A66 Northern Trans-Pennine project

TR010062

8.2 Change Application: Consultation Report - Appendix H: Proposed Changes Consultation Brochure

Proposed changes consultation

DC-01 – Change in speed limit west of M6 Junction 40

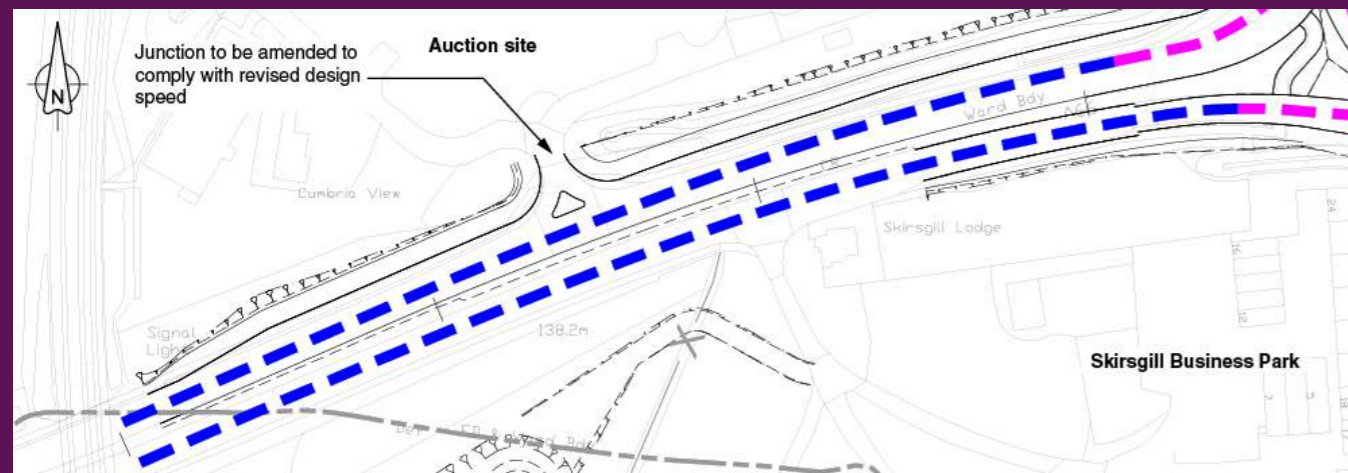
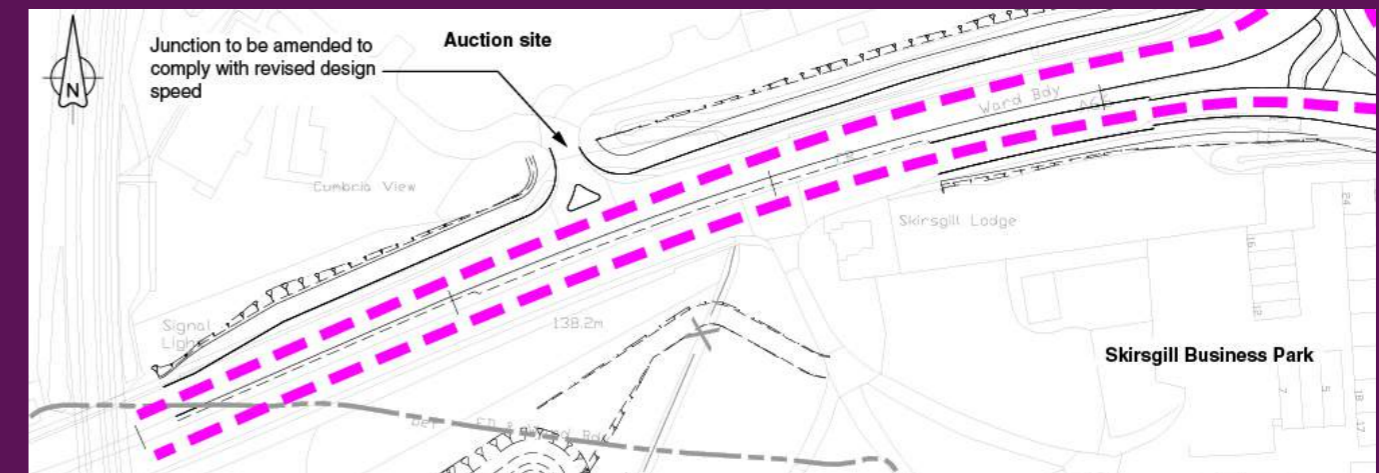
Our proposed change would reduce the speed limit from 70mph to 30mph on both the eastbound and westbound carriageways of the A66, between the railway bridge and Junction 40. As a result, there could be no need to add merge and diverge lanes to the auction site access. A more compact junction arrangement (similar to the existing access) would be safe and suitable.

This change would make the shared cycleway safer and reduce the speed of eastbound traffic passing the entrance/exit to the auction site as it approaches the roundabout at Junction 40 of the M6. The more compact arrangement for access to the auction site would be more in keeping with the existing access and would reduce our impact on the landowner and the auction business by reducing the land required.

DC-02 – Realignment of walking and cycling route at Skirsgill

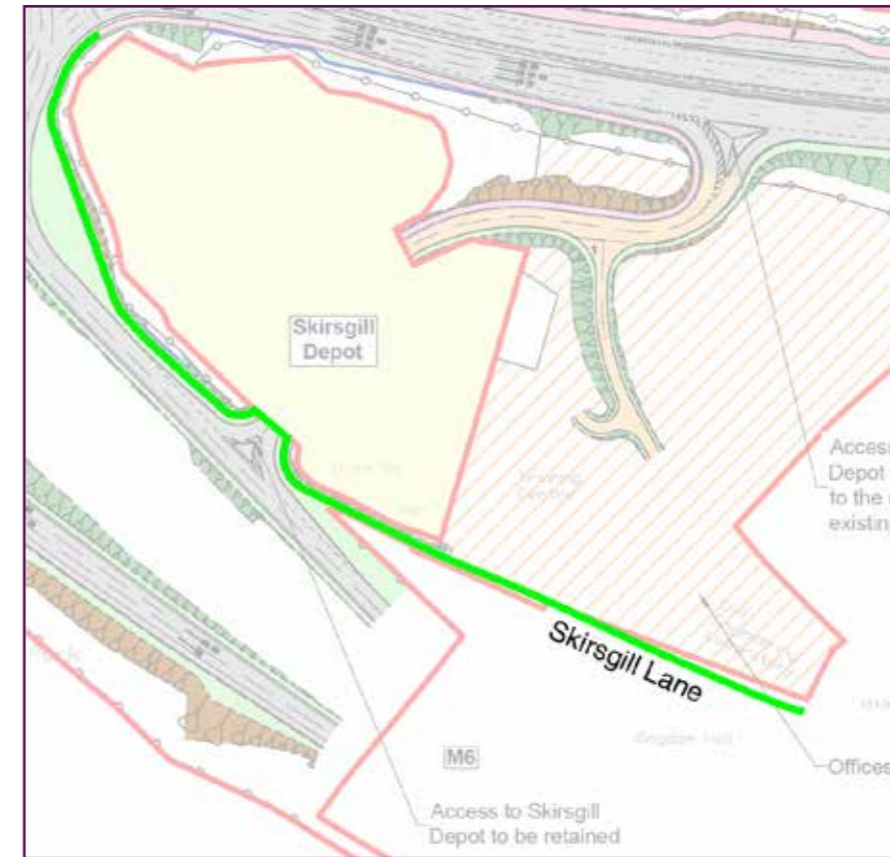
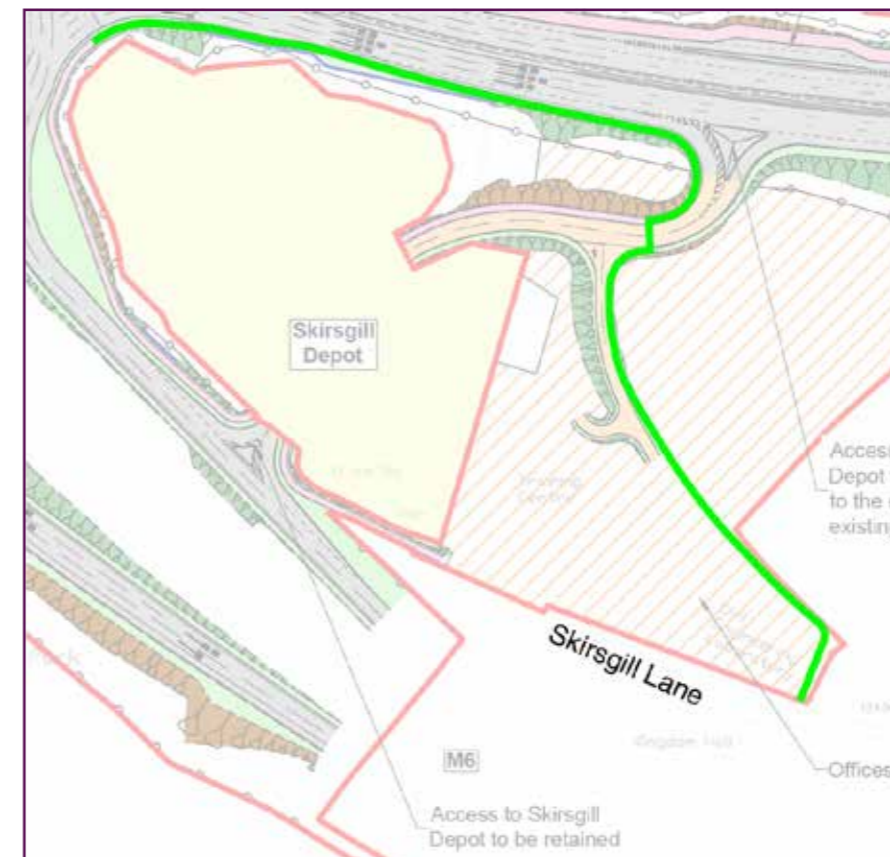
This change proposes that we divert the footpath from the slip road and re-direct it alongside the boundary of the Skirsgill depot to the north. Pedestrians and cyclists will take a route which runs adjacent to the A66 before heading south east to join Skirsgill Lane.

The proposed route is a more attractive and safer alternative for walkers and cyclists who would be redirected away from the M6 Junction 40 southbound slip road.

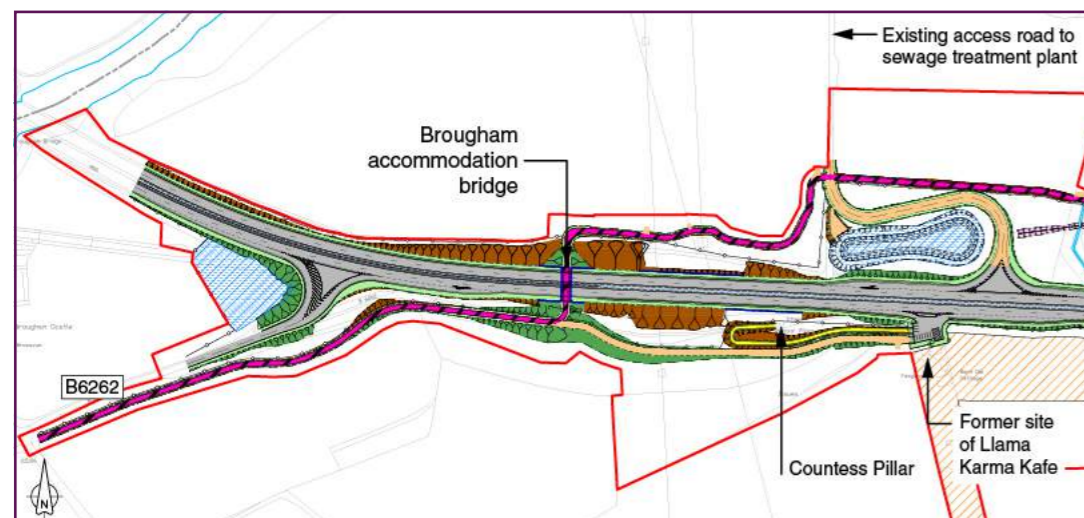
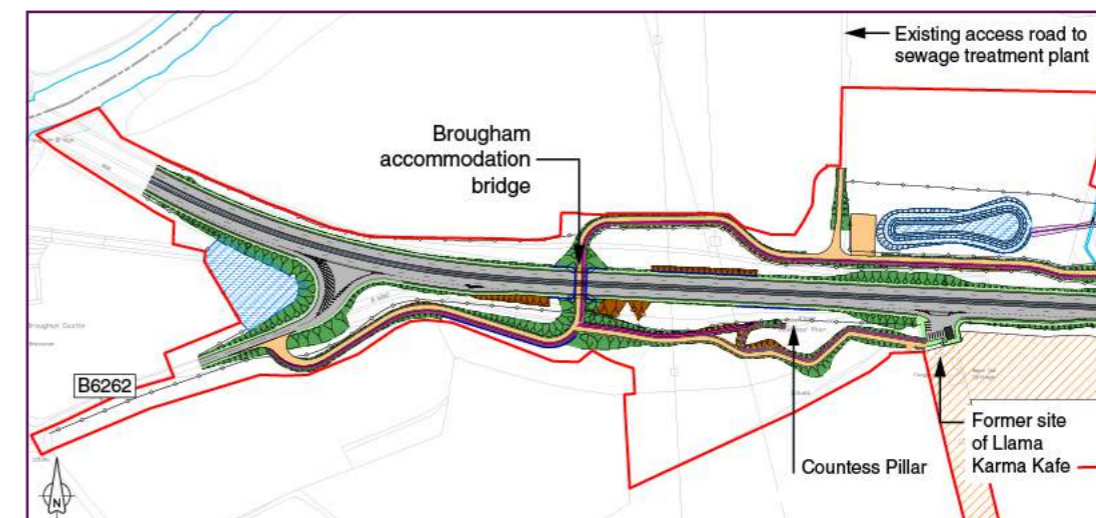
Our proposed change is to provide a private access track, shared with a cycle track, from the north side of the A66, crossing the A66 on a bridge and continuing to the B6262. This replaces what was put forward in the DCO application for access to the eastbound carriageway. On the southern side we would retain access to the Countess Pillar.

By removing the junction, we avoid a clash with the gas pipeline and reduce potential disruption and the risk associated with the road being built over nationally significant utilities which would make ongoing maintenance both unsafe and costly.

With this change, access to the A66 is provided to the westbound rather than the eastbound carriageway. In the DCO design drivers would turn around at Center Parcs to travel west and with this change, drivers would need to use the junction at Kemplay Bank to travel east. The distance to Kemplay Bank is

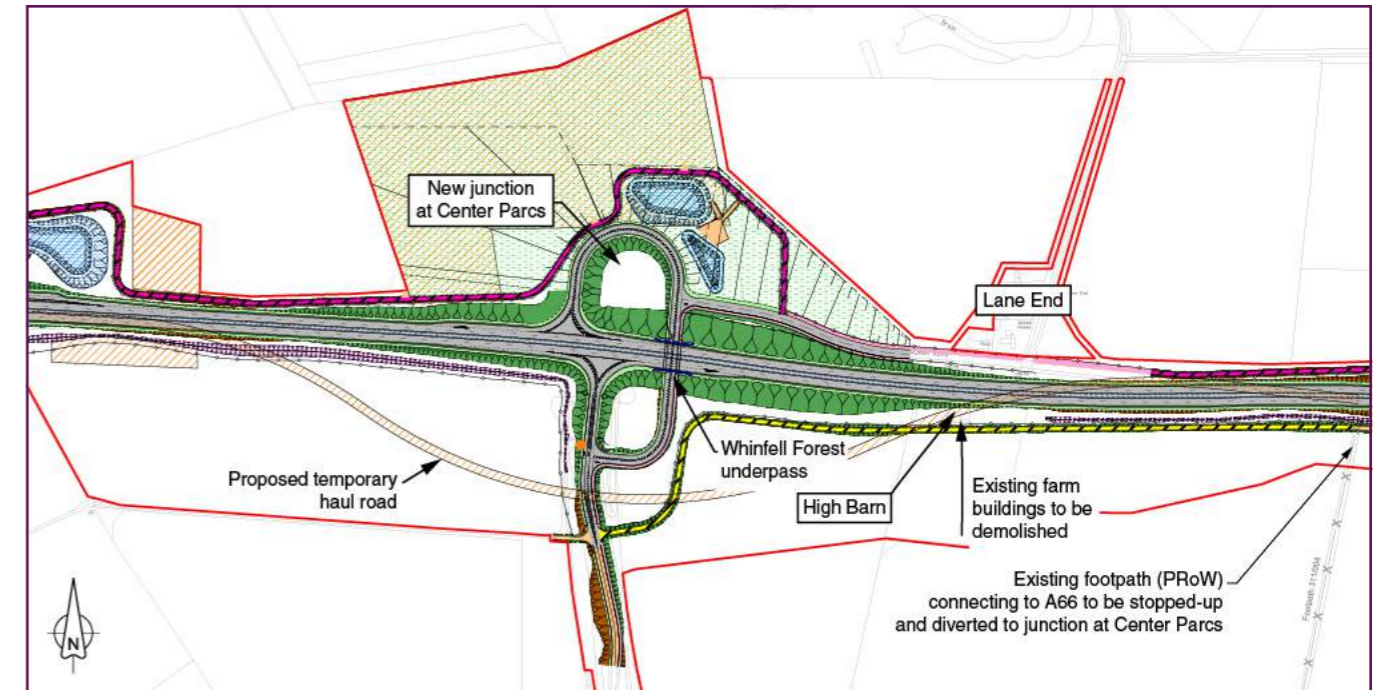
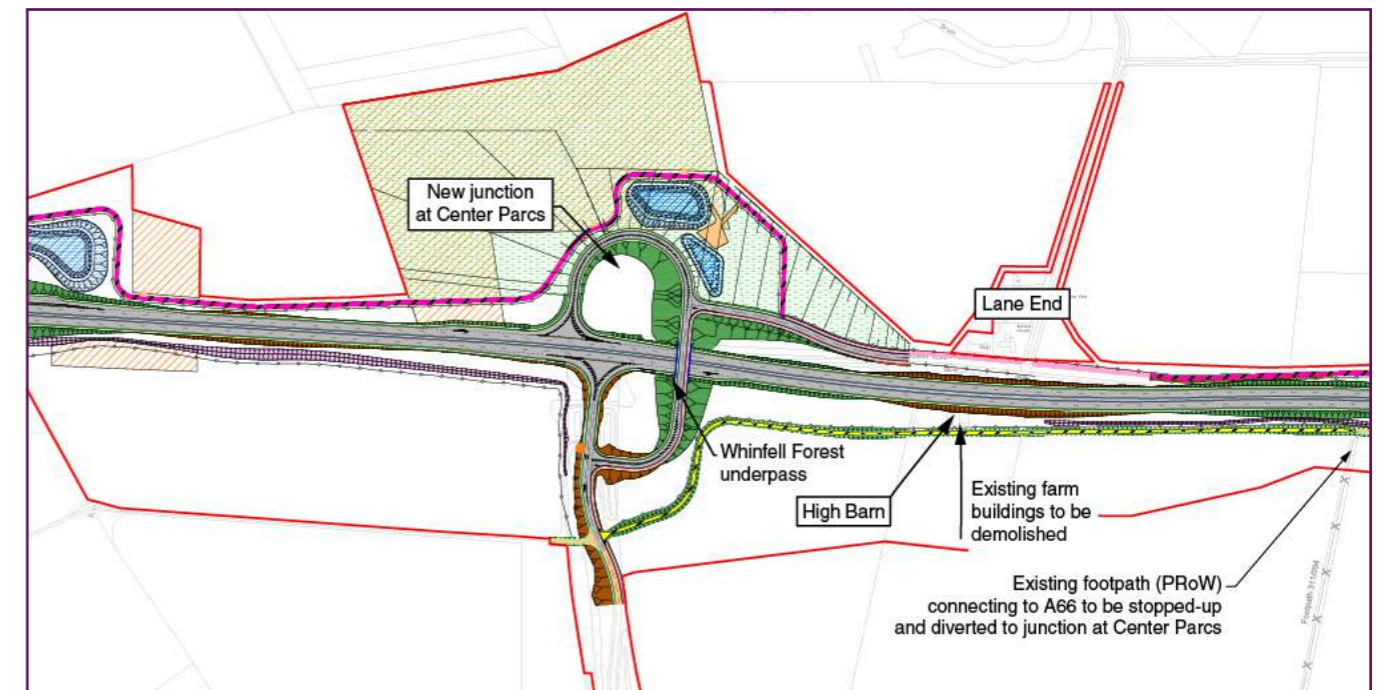
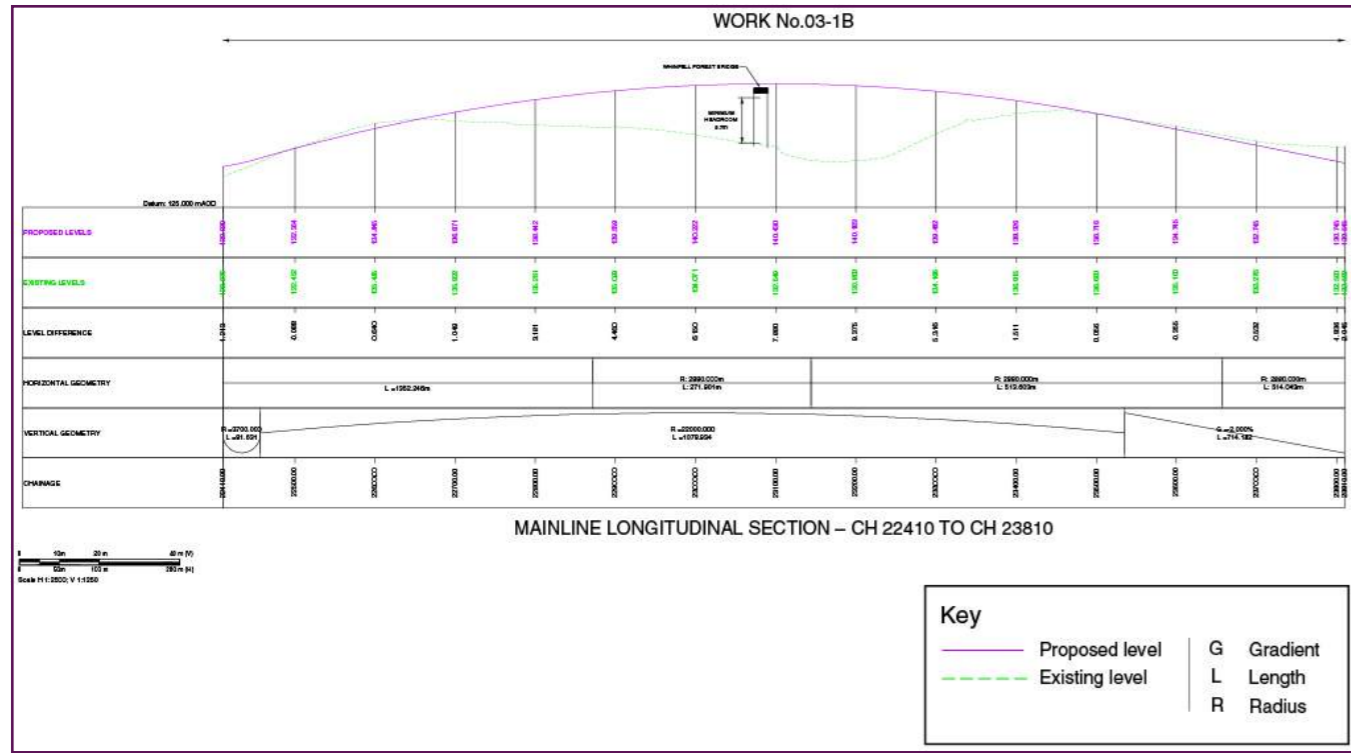
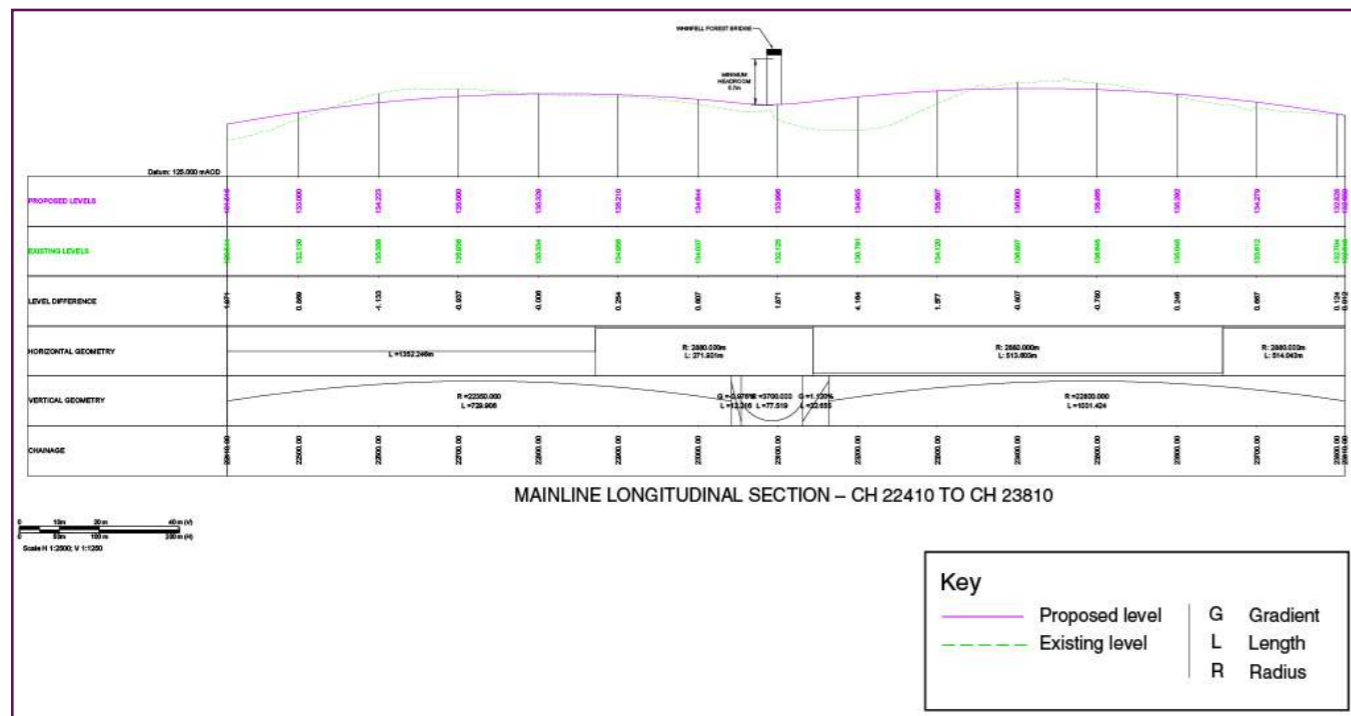
We are now proposing to invert this junction so that the mainline of the A66 would more closely follow the existing road at ground level rather than being elevated on an eight-metre-high embankment. The local road access, which forms part of the junction, would cross over the A66 mainline on a bridge rather than passing underneath it. The proposed bridge would be at a similar height to the embankments included in the DCO design.

The proposed change removes the need for the temporary diversion, which would have been around 1.2km, minimising disruption for road users. The new bridge would be built in two sections with traffic initially being retained on the existing A66 while the westbound carriageway and southern half of the structure is constructed. Once complete, traffic will be switched to the newly-built carriageway whilst the northern half of the structure and eastbound carriageways works are completed. This will substantially reduce the construction period and amount of temporary work in this location as well as reducing construction traffic.
